APPLICATION NO.	FILING DATE	FIRST NAMED INVENTOR	ATTORNEY DOCKET NO.	CONFIRMATION NO.
10/807,883	03/24/2004	Paul Gait	N1055	5602

Office Action Summary	Application No. 10/807,883	Applicant(s) GAIT, PAUL	
	Examiner Mike Chambers	Art Unit 3711

DETAILED ACTION

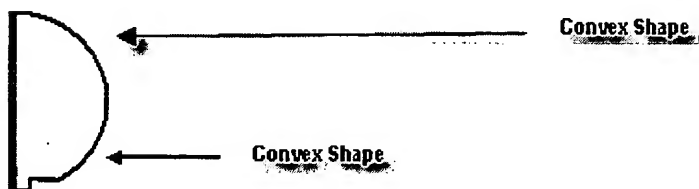
Applicant's arguments filed 2/20/07 have been fully considered but they are not persuasive. The existing claim language clearly reads on the cited art. The applicant's argument appears to focus on the recessed ridge (38). The simple fact is that item 38 is

not the main thrust of the invention in application 20020173388. As noted in the current response listing Paragraph 27 of the specification:

"Each inner surface 39, 41 is preferably configured to extend in a generally continuous fashion from the top surface 42 of the recessed channel 38 to the upper rim 34. In the preferred embodiment, this configuration is generally curved or arcuate. However, it will be understood that the inner surface 39, 41 of each sidewall may alternatively be sloped, inclined, convex, stepped, or any combination of the above. Moreover, different portions of a single sidewall can take on a variety of different shapes. (Emphasis added) (Paragraph 27, last 5 sentences)"

It clearly states that the sidewall can be convex. The limitations of the existing claim language in the instant invention merely calls for

"a portion of the length of the inner edge of each sidewall convexes inwardly toward the opposing sidewall and said portion of the length of the inner edge of each sidewall is convex toward the opposing sidewall from the upper portion to the middle portion and is convex toward the opposing sidewall from the lower portion to the middle portion"

In the simplest form, the sidewall of Morrow could be shaped like this:
